To replace Epia ML Motherboard with Epia M830

Epia has discontinued the ML and replaced it with the M830. The location of every connection on the motherboard except the power supply has changed, and the polarity on the power supply connector is reversed.

Epia M830 Connections

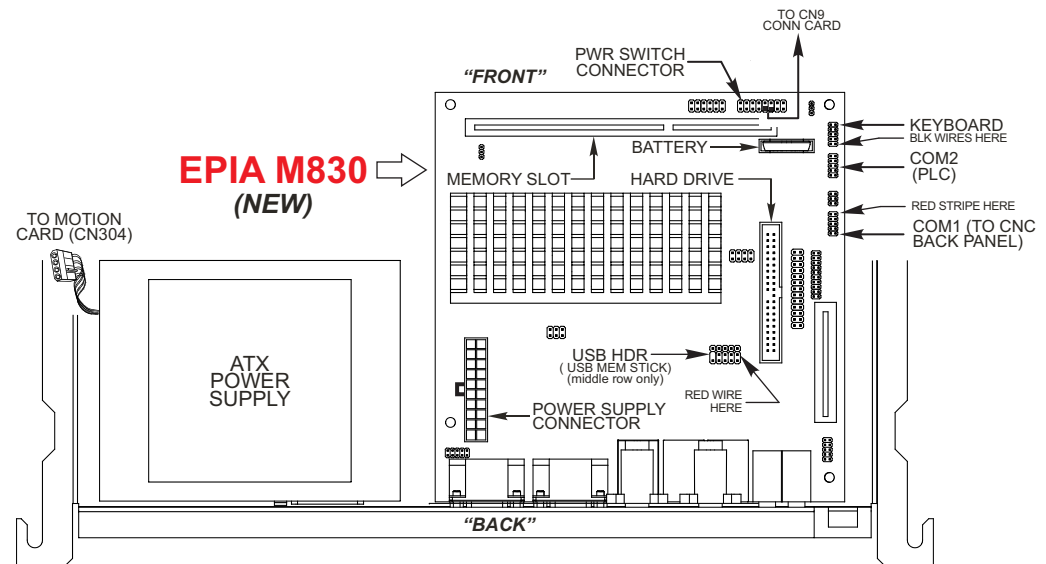
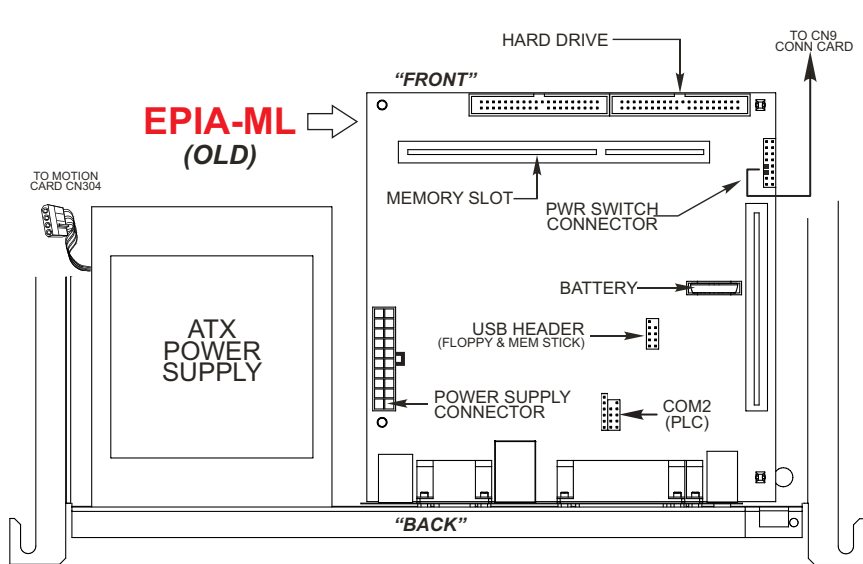
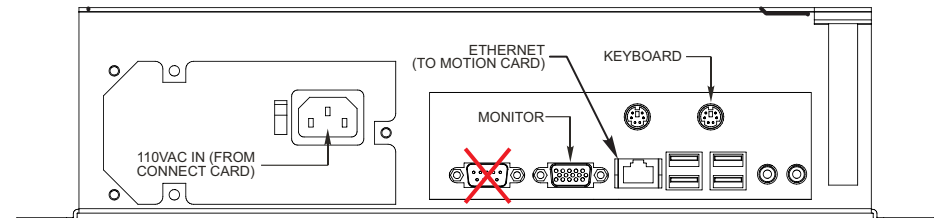
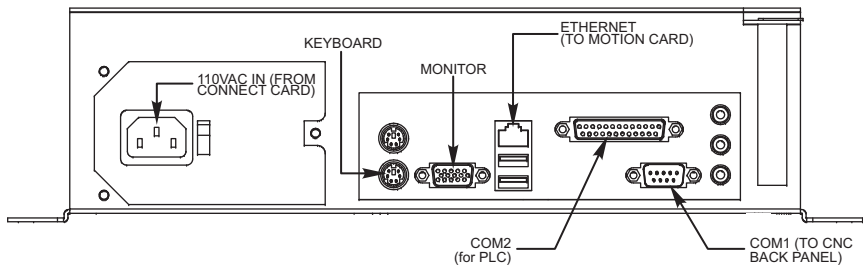
POWER CONNECTOR: Note that the locking tab is reversed on M830.

PWR SWITCH: Moved from right side to front; use existing cable.

USB HEADER: Only the center header is active; connect USB "thumb drive" cable here. Red wire to right. If your CNC has floppy drive, and you want to use it, call the factory to discuss options.

HARD DRIVE: Moved from right side to front of motherboard.

KEYBOARD: Connect to 10-pin at right front, with black wires toward back.

COM1: The 10-pin ribbon-cable from CNC back panel must be replaced with cable provided. Connect black 10-pin to header at right side of motherboard, with red stripe toward front.

COM2: If you have 25-pin connector at COM2 on Epia ML, replace that cable with adapter cable provided. Red stripe toward front.
